RECEIPT DATE: 9/18/24 **ONSITE SEWAGE DISPOSAL SYSTEM** P 587810

APPROVAL DATE: 1/29/25 **PERMIT: NEW CONSTRUCTION** A _____

PROPERTY ADDRESS: 11079 Gaither Farm Road

SUBDIVISION: Gaither Farm LOT: 15 TAX ID: _____

HO-18-0017

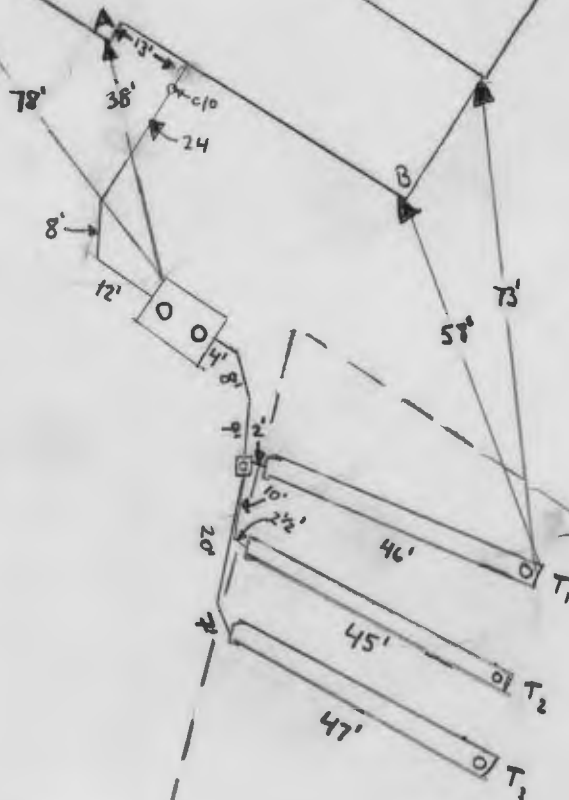
12/19/2024 - Installer onsite for pre-con. things. sewer installed @

diff in front plan. Installer wants to move tank slightly so that's 106 levels in front line & outlet in line with upper septic trench. D-box also moved in front of upper trench. STA & trenches existed, some ft in on site existing trench beginning to move down 9' & end up 13' moved down 5'. Will not impact the existing or to start things.

12/19/24 Contractor has trench #1 and #2 dug. Trench #2 has been backfilled with the end left open. Top of stone to grade is about 3.5'. Geotextile fabric added and absorption pipe added OK to backfill trench. Trench #1 bottom is per plan. Bottom of pipe is 4'. Contractor will leave front of trench open for tomorrow. Tank will be arriving on Monday at 10am. (MB) 12/20/24 Contractor installed d-box and lines running into trenches. Stoning the back line with 57 stone. Trench 3 has been dug. Top of stone is 3.5'. Geotextile fabric laid. D-box is level and has a baffle. OK to backfill trench 3 and pipe leading to trenches. Contractor to leave d-box open till Monday. Plans to dig the septic tank hole tomorrow (Saturday) (MB) 12/23/24 Contractor has septic tank installed and leveled. Completed back line to d-box bedding the overdig with 57 stone from ST to d-box. D-box is leveled. OK to backfill (MB) 1/29/25 Marc Hereth is now registered with MDE. (MB)

After reviewing the updated plan, I have decided that the changes that were made out in the field are significant enough and differing from the recently submitted & revised OSDS plan that one more re-draft will be required.

I have attached our as-built drawing per the installation. One key aspect, as you can see, that I found hard to ignore was the fact that the main septic line is coming out of the house at a different location. And I'm surprised the septic contractor did not reach out or provide more accurate details to your engineering firm regarding the tank location changes.

- 1. The main sewer line is no longer coming out of the basement but is now a hung sewer. (septic profile will need to be adjusted)**
- 2. Minor grading occurred at the SDA. (this should NOT have happened)**
- 3. The tank, dbox location, and drainfield lines have been altered to deal with these unforeseen changes.**
 - a. Tank turned slightly to get on contour better.**
 - b. Dbox re-located to be in line with first trench.**
 - c. Drainfield ends closest to dbox are being slid down 9-12 feet to get level with the new contour (caused by disrupted grading)**

Everything looks pretty good. Let's make sure we have 10' spacing between the initial system and the 1st replacement system, which means we may have to slide the two replacements downhill. Other than that, should be good to go.

Those changes look accurate, but the distribution box will be at the start of the first trench. The elevation numbers should change to reflect that in the necessary places on the plans, and the hung sewer should be clearly showing the steeper line and be updated on profile. Hard to see the intended change with just the two very small red dashes. I would try to match up the trench details also with those new elevation points you show on the plan next to the drainfield ends for the initial system.
